Project Description – 1201 Abercorn Street

This application covers two minor changes to the project originally proposed and approved by the Historic Preservation Commission in COA 24-002994. Besides the changes listed below, the exterior scope remains the same as originally approved. This application only contains information about the changes.

1201 ABERCORN IMPROVEMENTS

1
A1.1
MAIN FLOOR PLAN
1/4" = 1'-0"

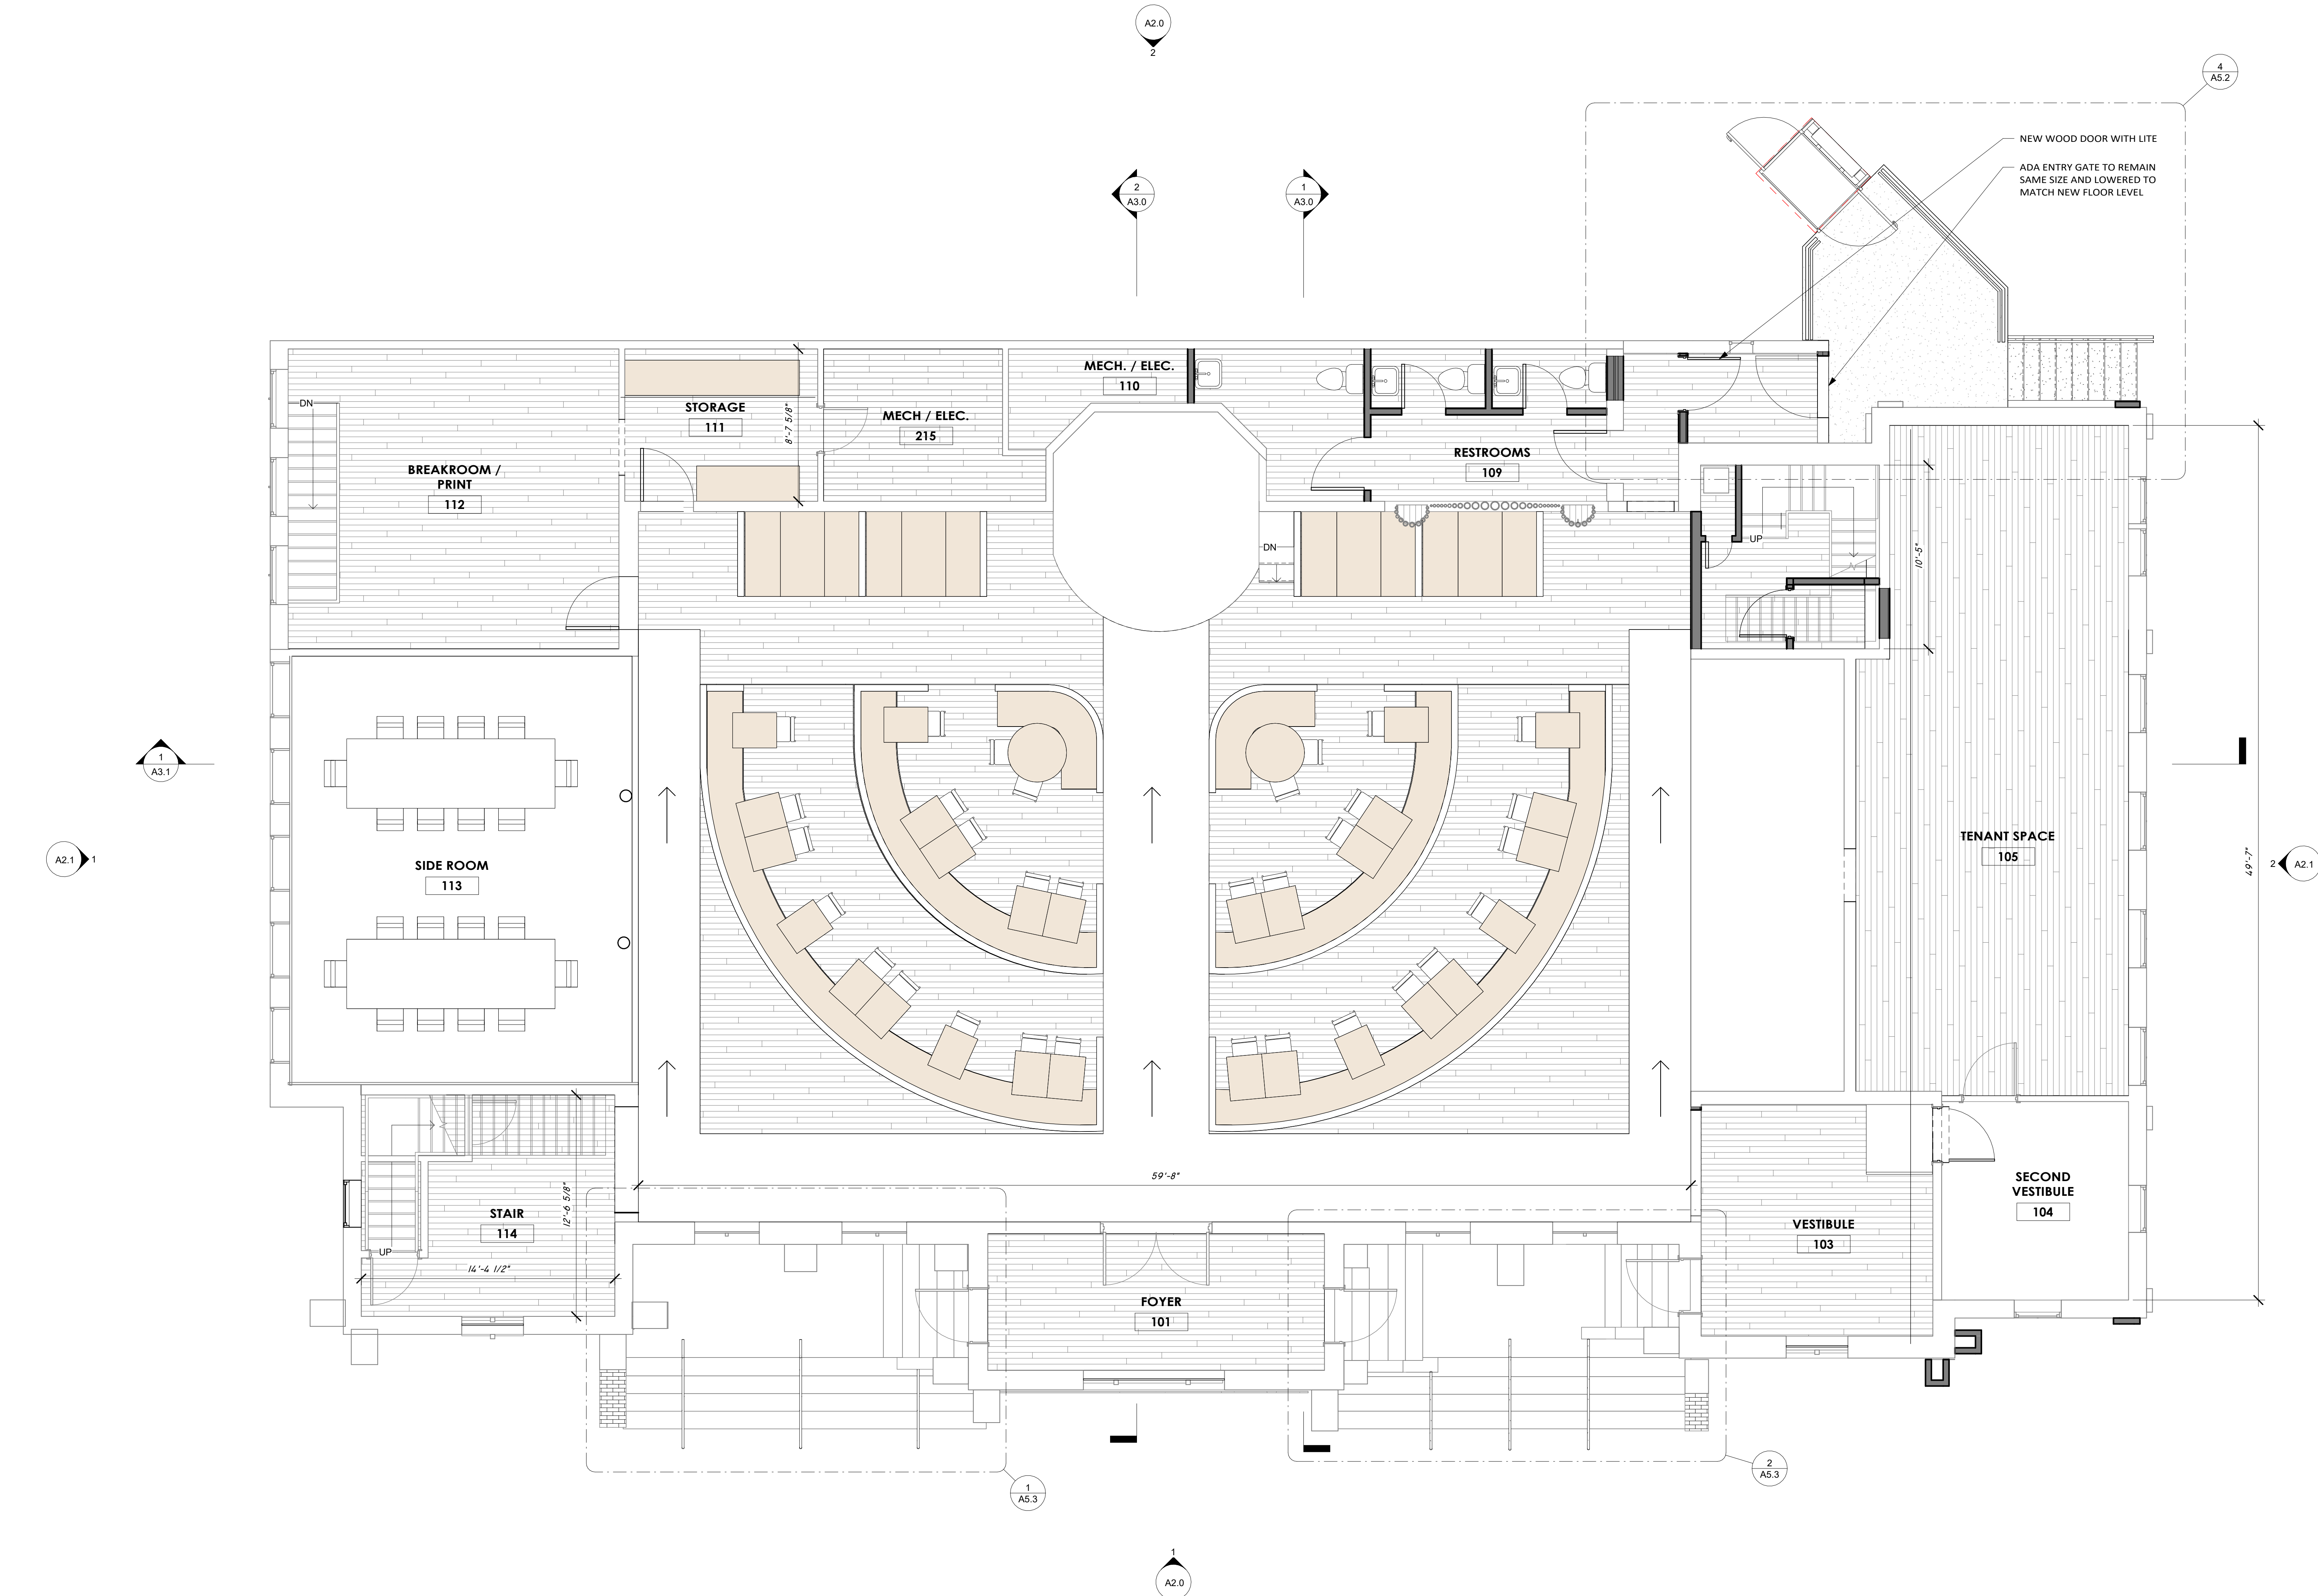
The handrails on the main steps on the east elevation (front) were removed per the previous proposal. In order to meet life/safety codes, new handrails will be installed. The new handrails will be simple metal handrails that are finished with a dark powder coated finish. These handrails will be minimally visible once installed. See sheets A1.1 and A5.3 for locations and details of these handrails.

A2.1

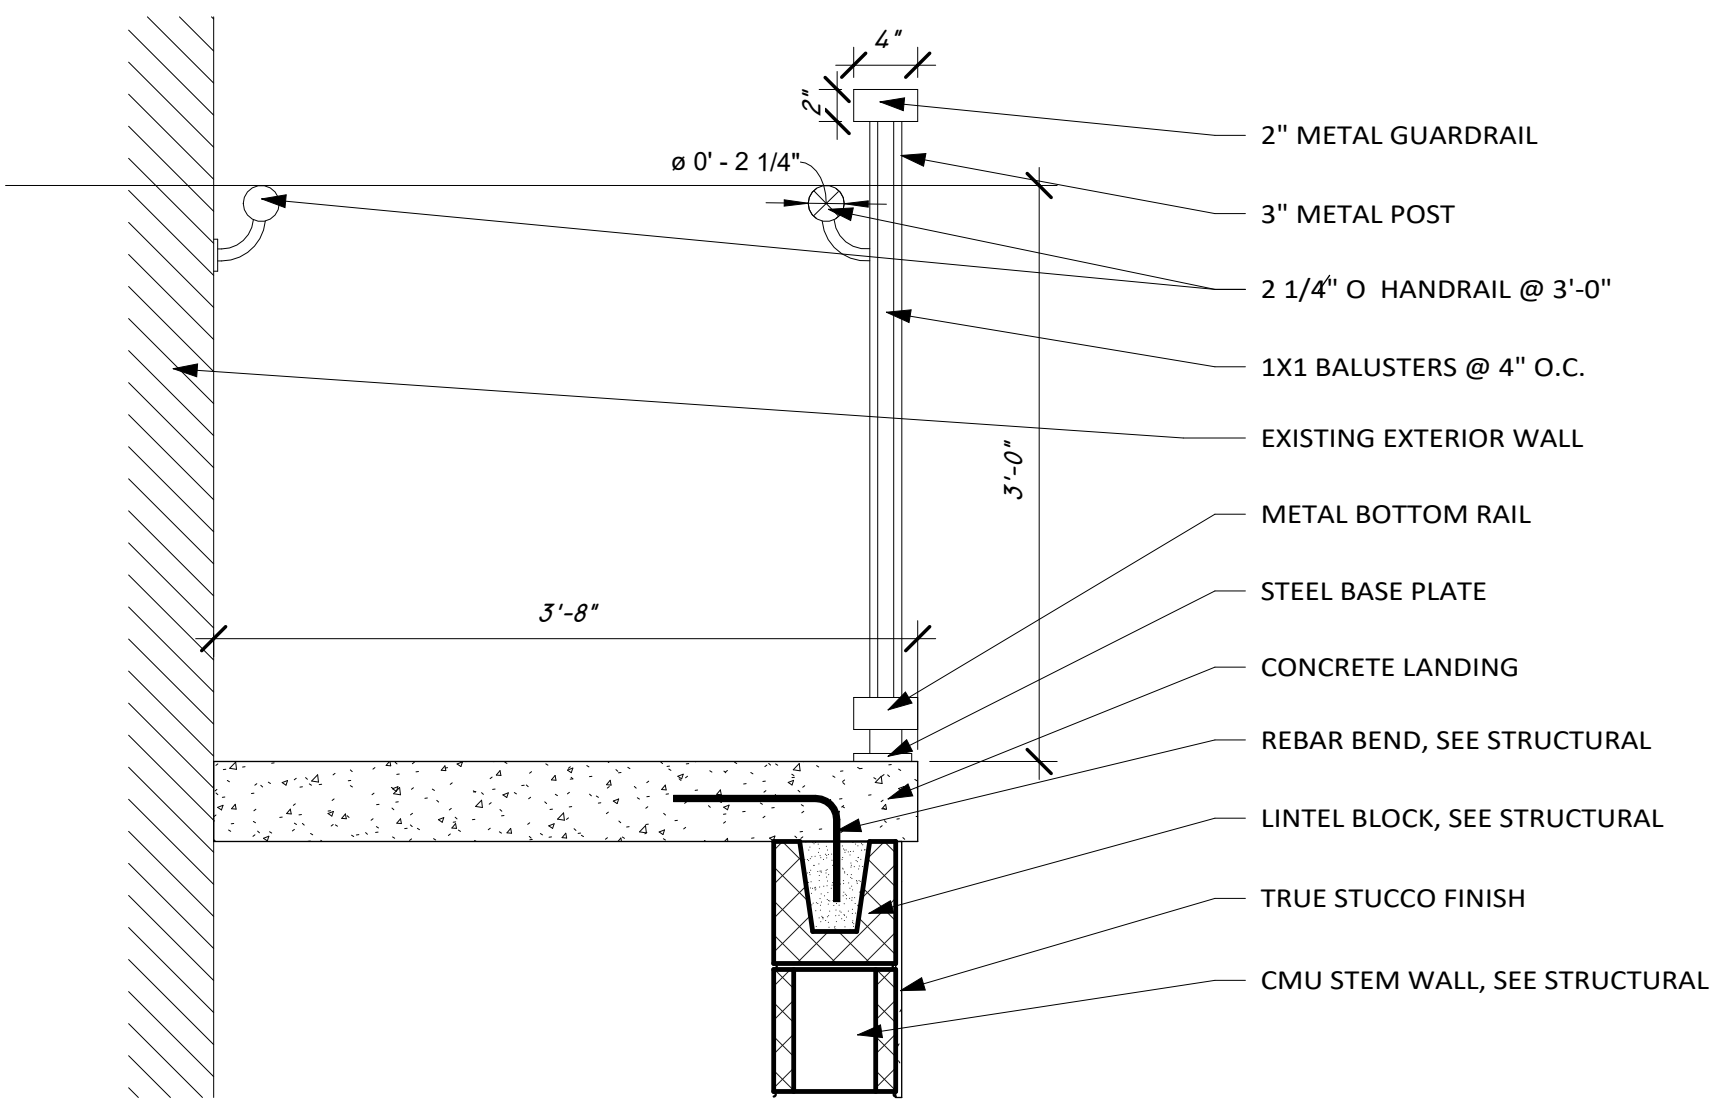
The ADA entry door will be replaced. This entrance is located on the rear of the building. The existing door is a flush steel door that has been painted and is not historic. The new door will be a custom-built wood paneled door as shown on the plans on sheet A2.1 North Elevation.
